Determination 2021/024

Regarding the compliance of a proposed pool barrier incorporating an existing boundary fence at 1/92A Upper Harbour Drive, Greenhithe, Auckland

Figure 3: Sketch of boundary fence (not to scale)

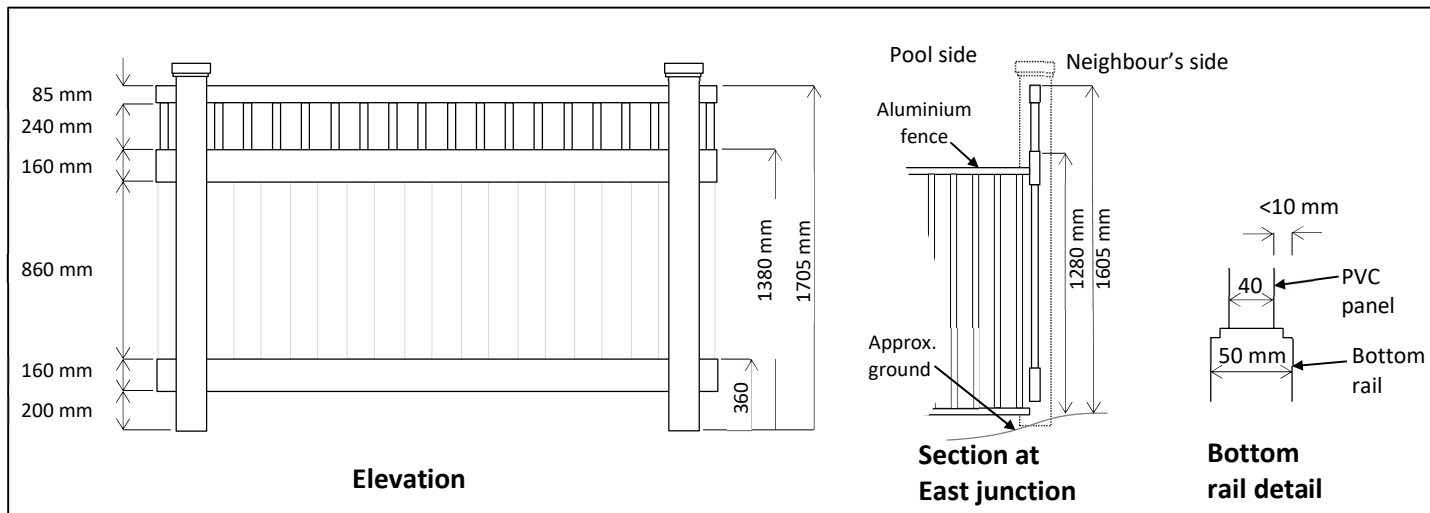
5.20 The authority has expressed concern about the area of detailing near the top of the fence, which it considers creates a “climbable point” that young children could use to help them negotiate the fence. The detailing includes the middle rail and the vertical members. While I do not consider that any of these elements could be described as “projections”, I acknowledge the authority’s concerns and agree that these elements’ impact on the assessment of compliance with Clause F9.3.1.

- 5.23 In my view, the area of detailing at the top of the fence provides hand- and foot-holds that will assist a young child to negotiate the barrier. The size of the middle rail (at 50 mm wide) and the spacing between members (95 mm) make the middle rail and the vertical members (at 40 x 40 mm) graspable by a young child.

- 5.24 From the neighbour's side, the height of the fence from the ground to the top of the middle rail is 1280 mm. Although this is above the 1200 mm, which is the height of barriers in the Standard and for barriers other than boundary fences in the Acceptable Solution, it is not significantly higher and will be within reach of a child¹⁰ standing on the neighbour's property.

- 5.27 In my view, taking into account the various features discussed above, the boundary fence in this case does not present such a challenge. In conclusion, I consider the boundary fence will not restrict access of young children to the pool area and therefore does not comply with Clause F9 as an alternative solution.

- 5.28 The owners must now devise a new design for their pool barrier that achieves compliance with Clause F9. They may elect to either modify the existing boundary fence or build a new barrier, which the authority will then assess for compliance.

Figure 4: Sketch of east junction (not to scale)

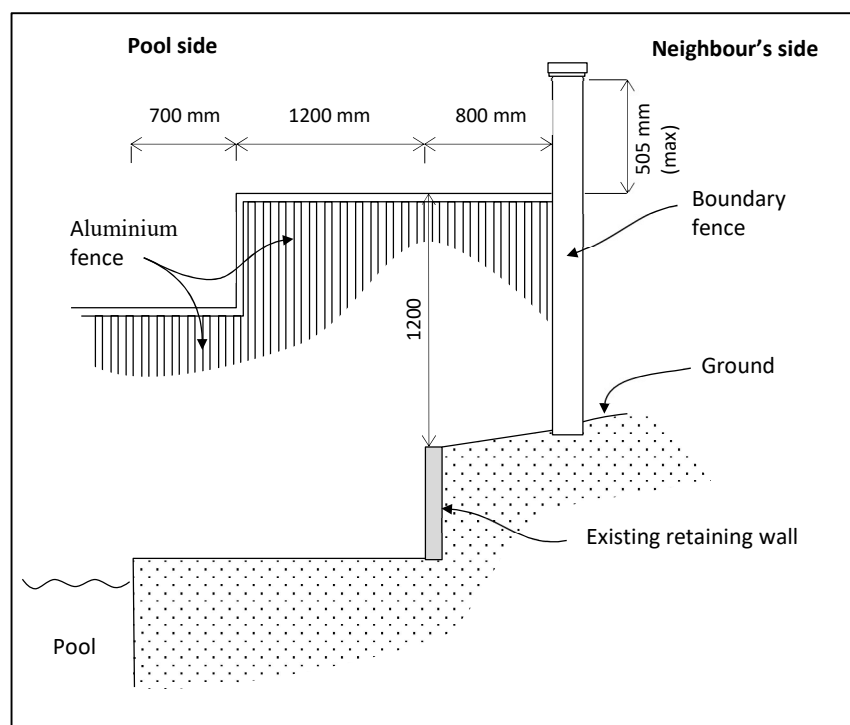
- 5.25 The vertical members and middle rail would also enable a young child to climb down into the pool area from the top of the barrier. In addition, the east junction of the fence with the 1200 mm high aluminium internal fence could further assist a young child to climb down into the pool area. The top point at which this internal fence meets the boundary fence will be approximately 400-500 mm below the top rail of the boundary fence, and less than 180 mm below the middle rail, providing further foot and hand-holds on a descent into the pool area.
